# SAS-2 External Link Crosstalk Budget Suggestion and Analyses

**T10/06-104r0**

# Suggestion for miniSAS4x Crosstalk (after Galen Fromm, Molex)

Table 41 — ~~Additional~~ Requirements for external cable assemblies using Mini SAS 4x All data rates

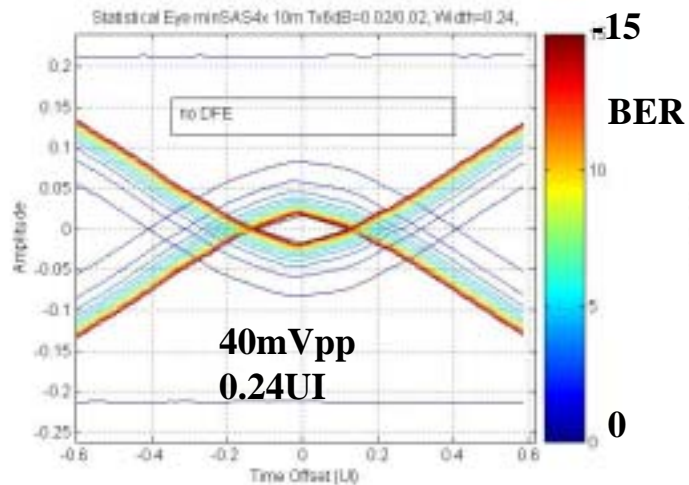
Requirement <sup>a, b, c, d</sup>	Units	<del>1,5 Gbps</del>	<del>3,0 Gbps</del>
Maximum near-end crosstalk for each receive pair	dB	<del>-26</del>	<del>-36dB</del>
<p><sup>a</sup> All measurements are made through mated connector pairs.</p> <p><sup>b</sup> Determine all valid aggressor/victim near-end crosstalk transfer modes. Over the complete frequency range of this measurement, determine the sum of the crosstalk transfer ratios, measured in the frequency domain, of all crosstalk transfer modes. To remove unwanted bias due to test fixture noise, magnitudes less than -50 dB (e.g., -60 dB) at all frequencies may be ignored. The following equation details the summation process of the four valid near-end crosstalk sources. All NEXT values expressed in dB format in a passive transfer network shall have negative dB magnitude.</p> $\text{TotalNEXT}(f) = 10 \times \log \sum_{1}^{4} 10^{(\text{NEXT}(f)/10)}$ <p><sup>c</sup> The range for this frequency domain measurement is 10 MHz to 4 500 MHz.</p> <p><sup>d</sup> The far end of the mated cable assembly shall be terminated in its characteristic impedance. Insertion loss variations (i.e., cable length) may change the measurement result.</p>

Note: PMC-Sierra measured total level of crosstalk is below -40dB
